EAST TRAILS MIDDLE SCHOOL - PRECAST 3" METER VAULT CONSTRUCTION DRAWING REVISIONS
RESPONSE TO CITY COMMENTS
FEBRUARY 7, 2022

WATER METER VAULT DETAIL
NOT TO SCALE

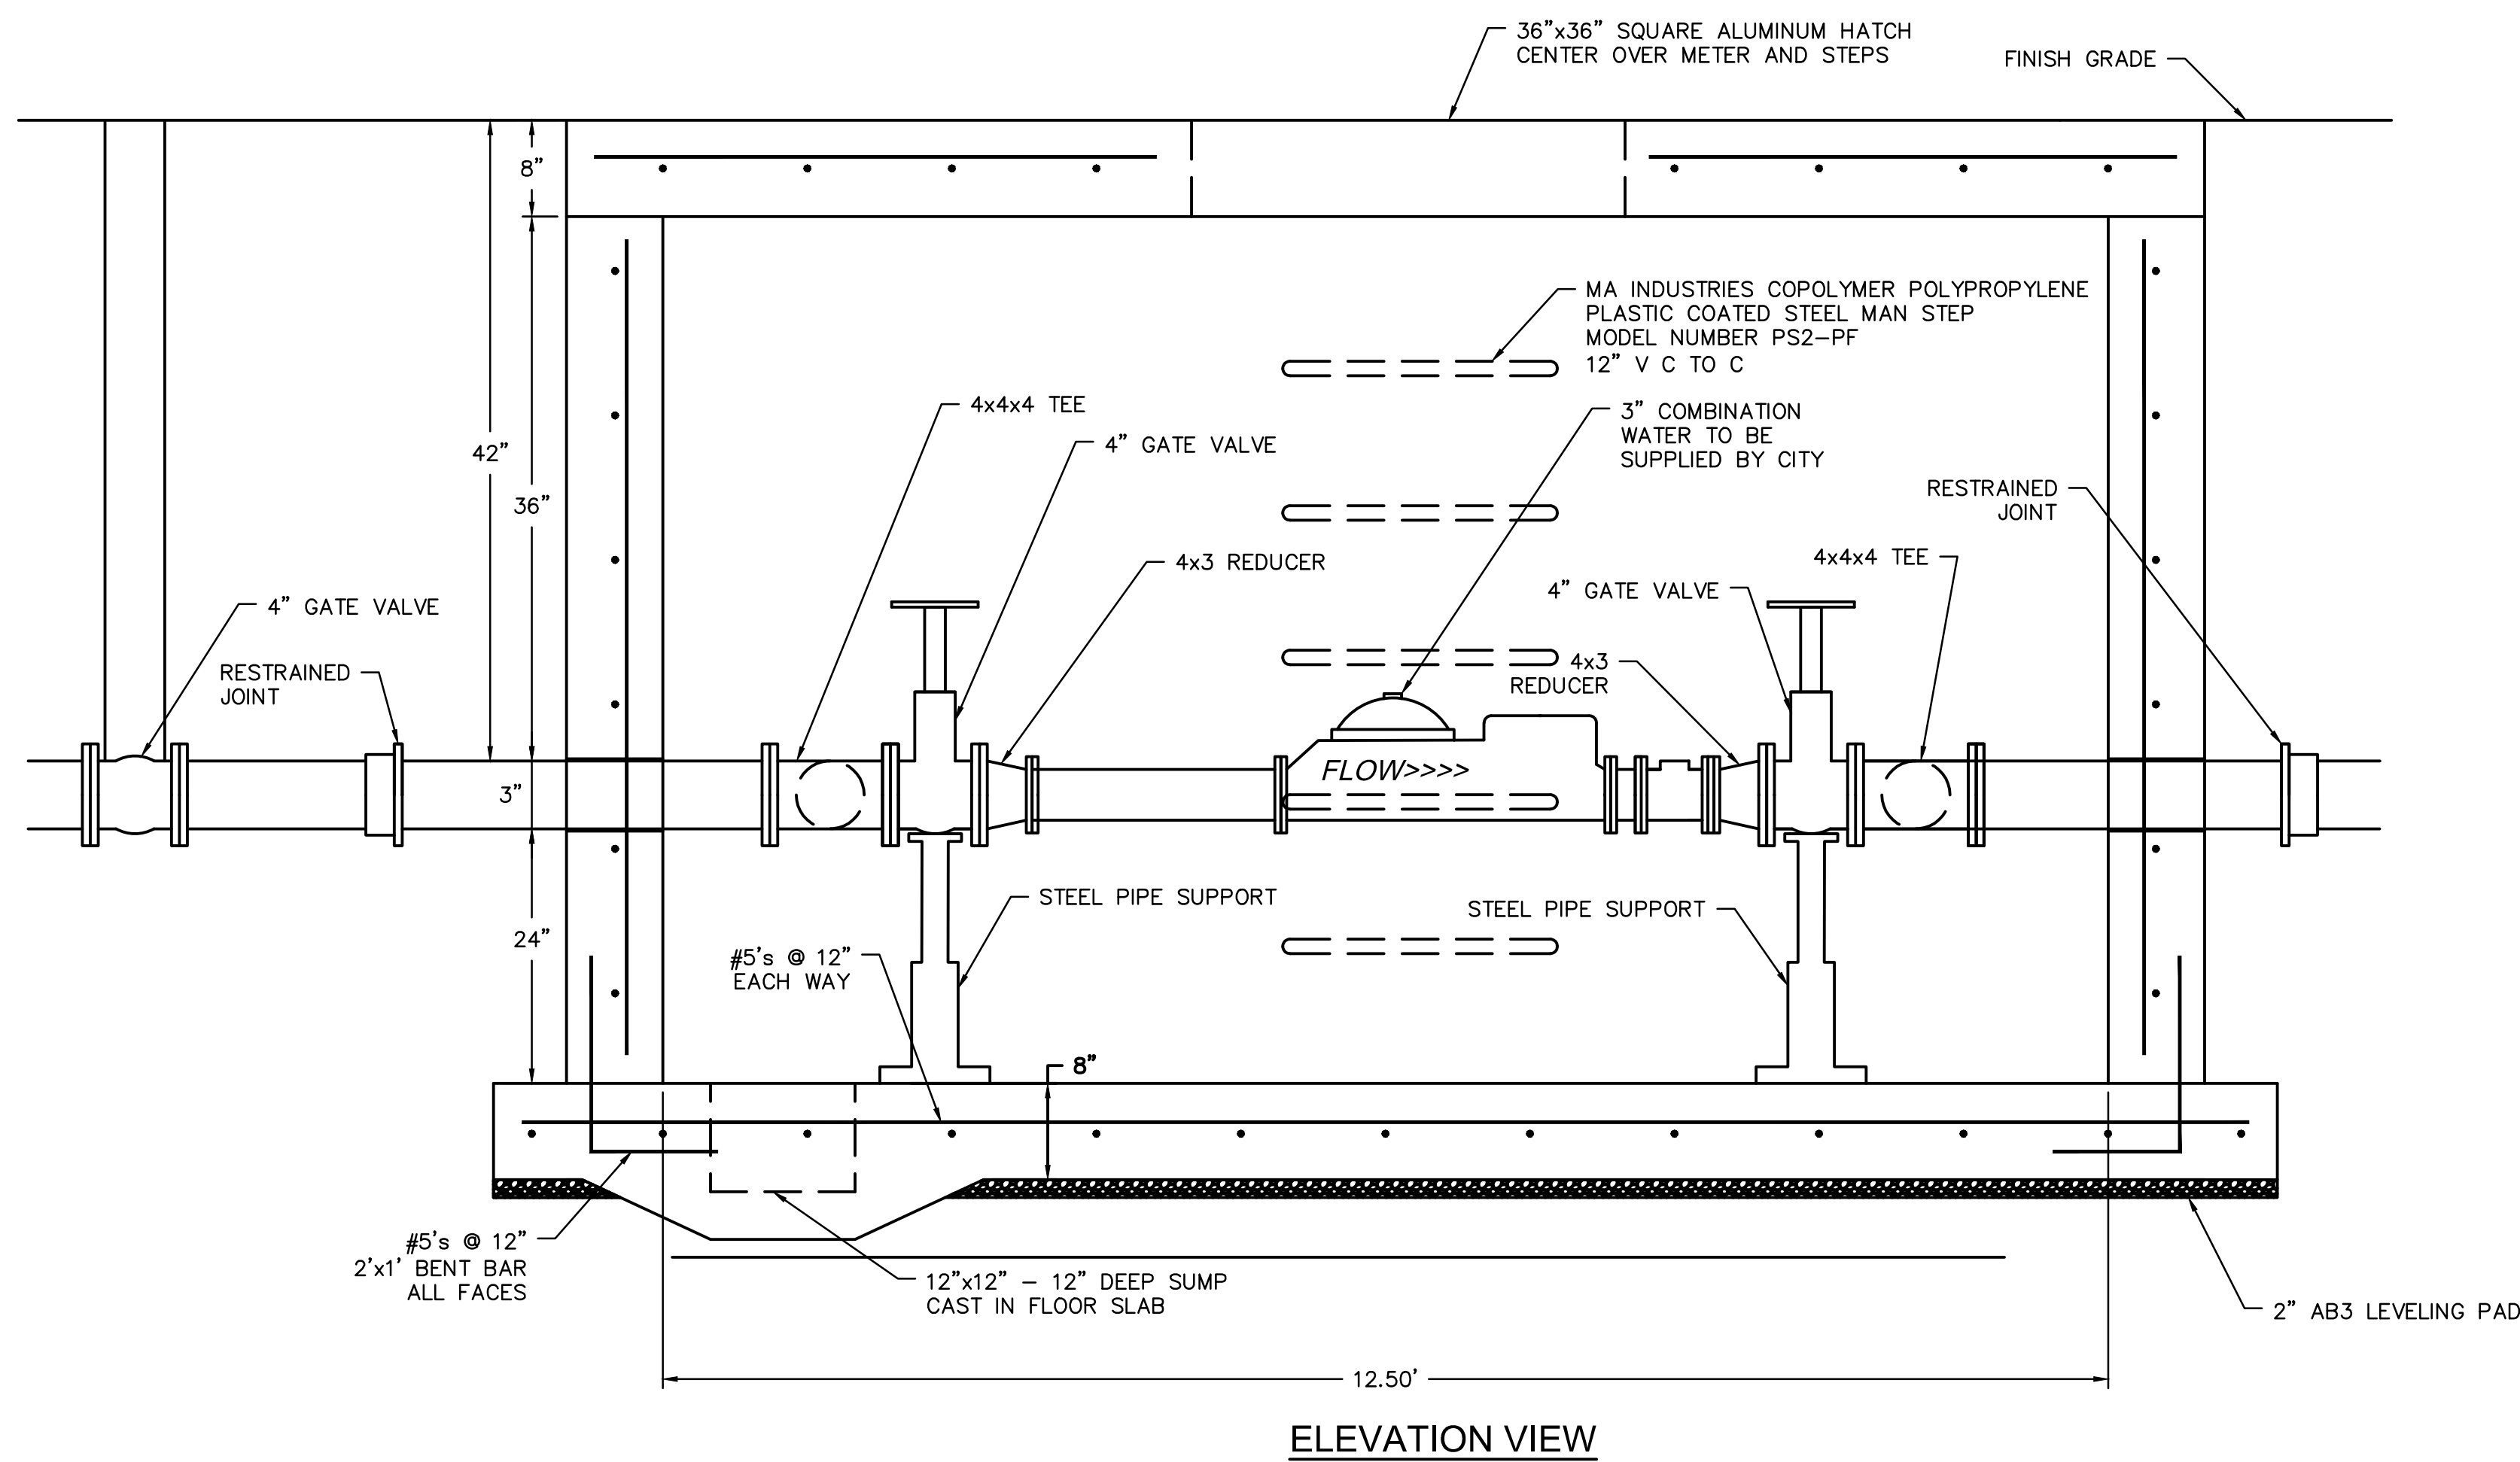
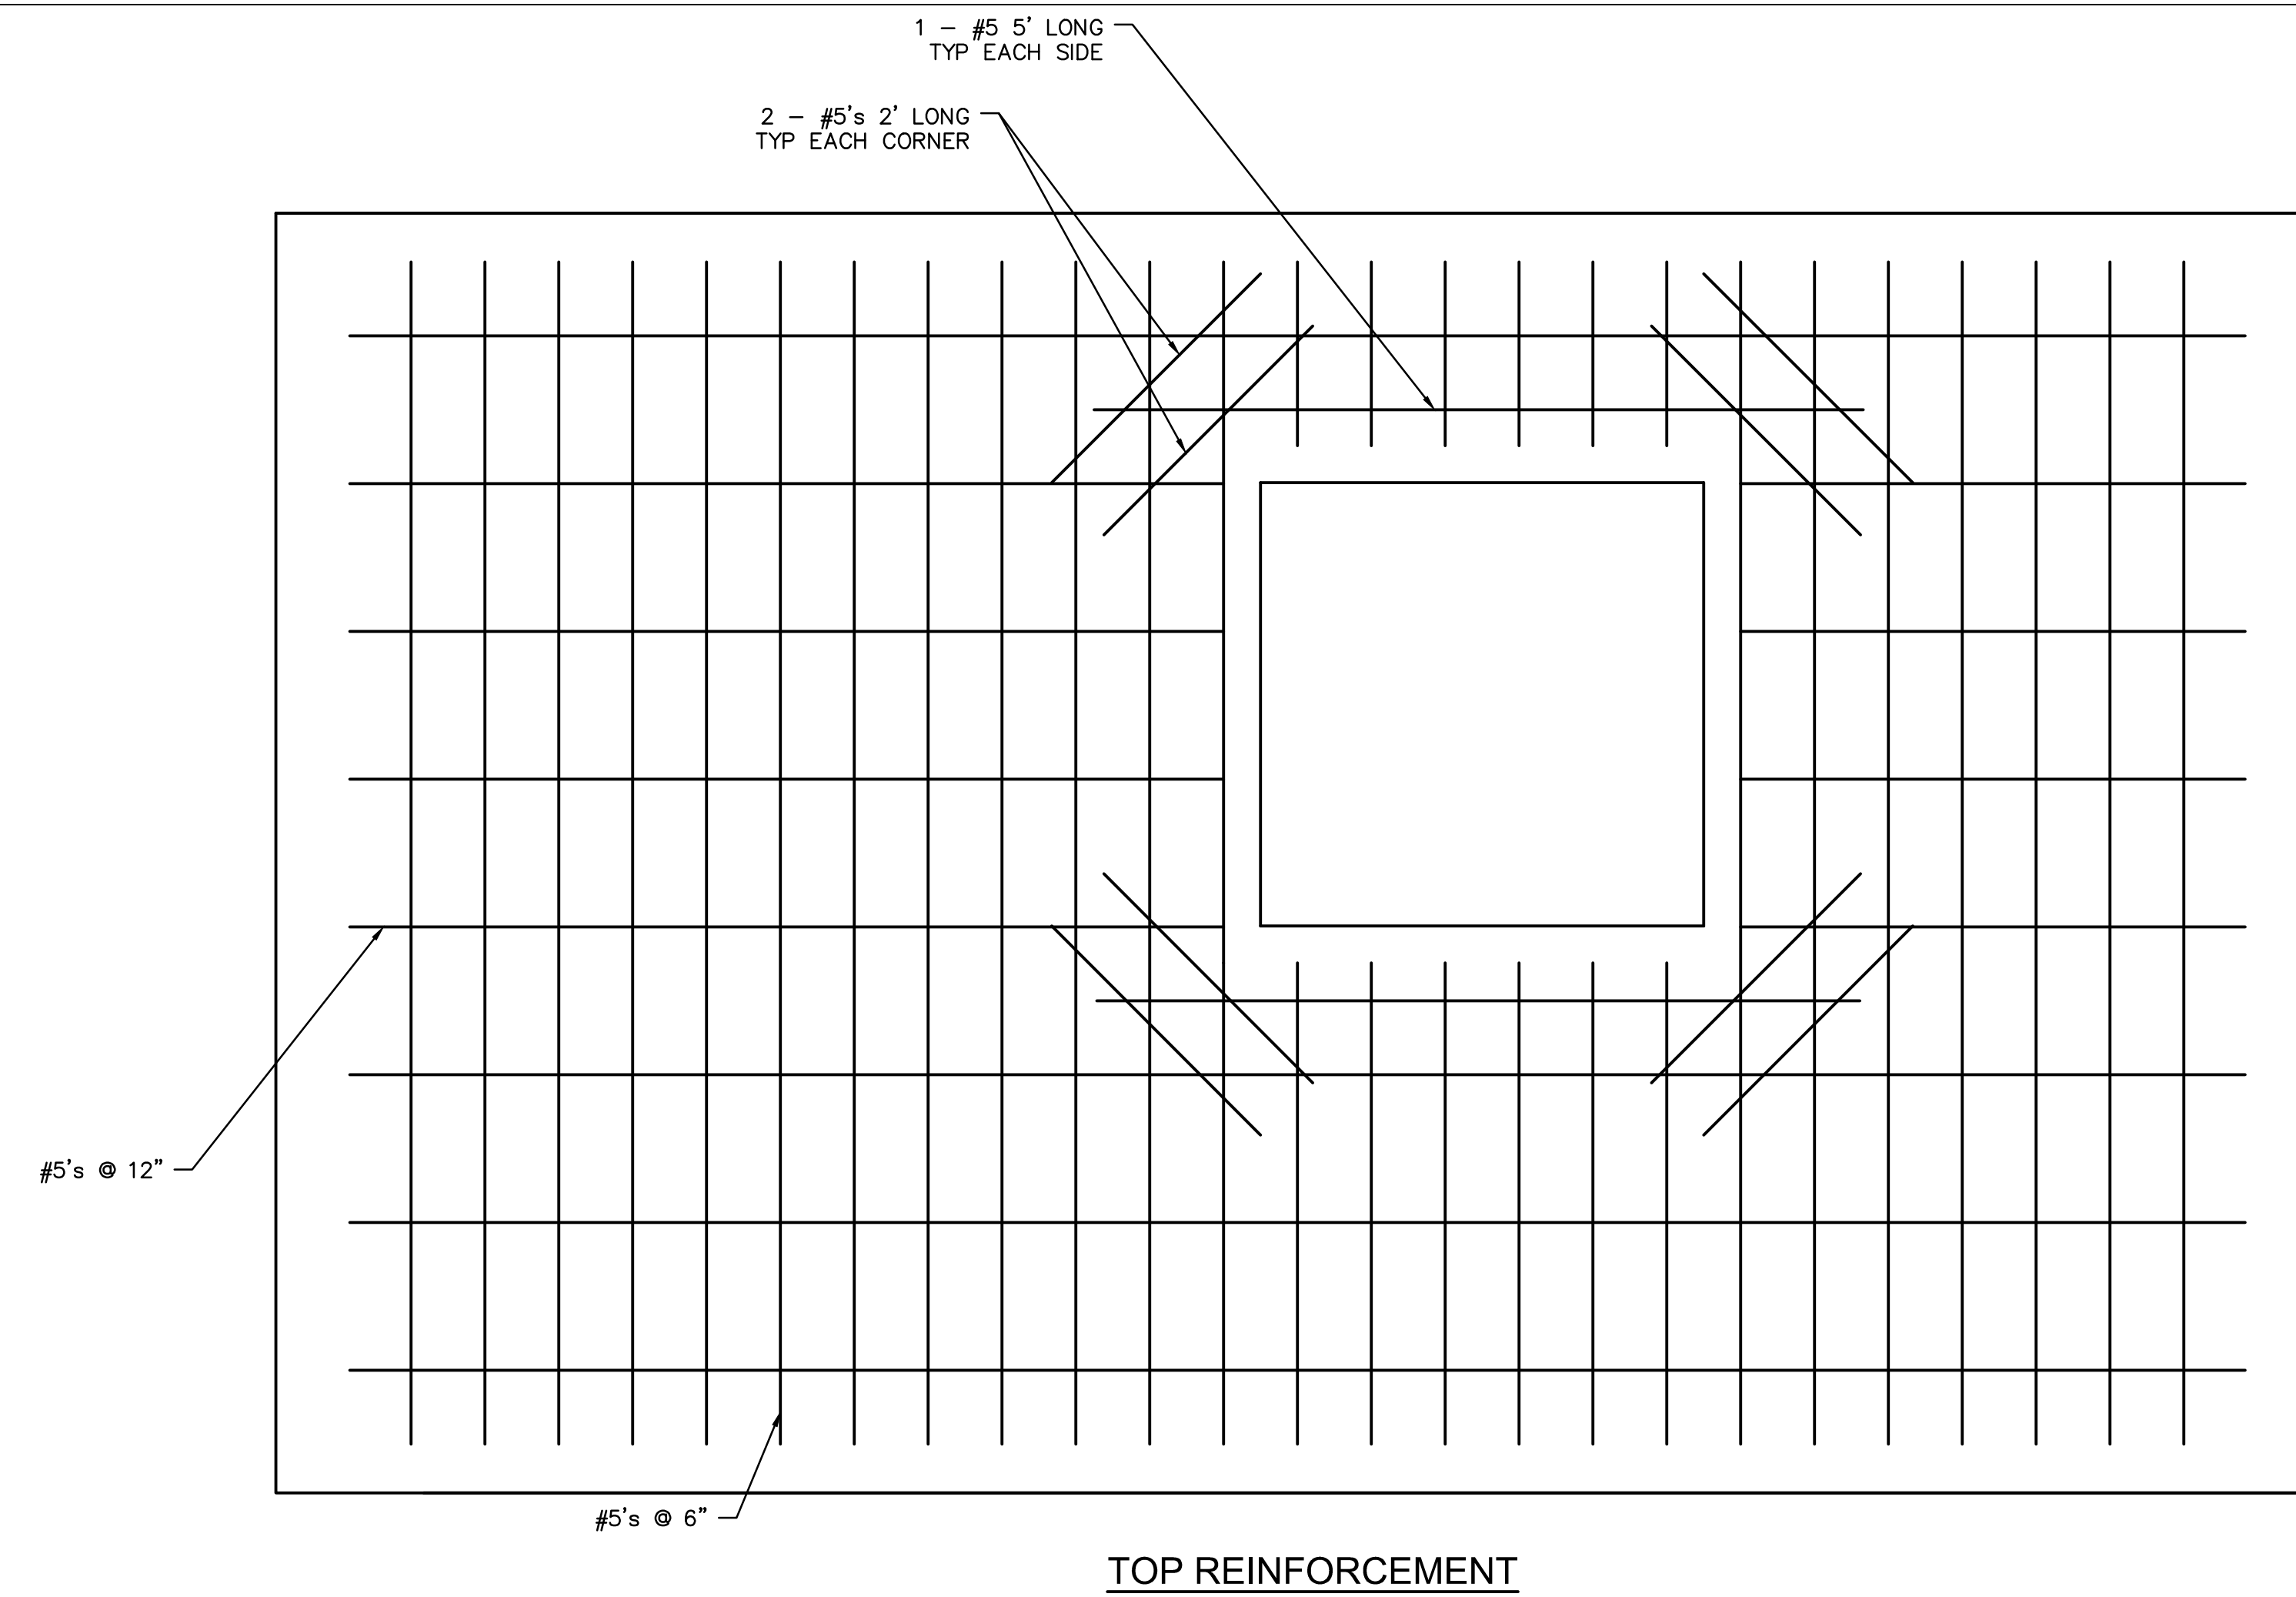
4	Since this is cast in place, where is the leveling mat? A granular leveling mat appears warranted rather than bare earth foundation.	The detail on Sheet C1050A has been revised to include a 2" AB-3 leveling layer under the vault slab.
5	Sump has no mechanism to drain. In a similar fashion to backflow vaults, provide the method to drain the meter vault either by daylighting, connection to a private storm inlet or box, or infiltration gallery. Provide notation on the revision showing how this will be accomplished, and revise the utility plan sheet to reflect the change as appropriate.	A sump has been added to the detail on the new Sheet C1050A. Sheet C1027 has been updated to show a 2" PVC drain connection to this sump (Keynote BD-2). This drain is being wye'd into the drain for the Backflow Preventor Vault.
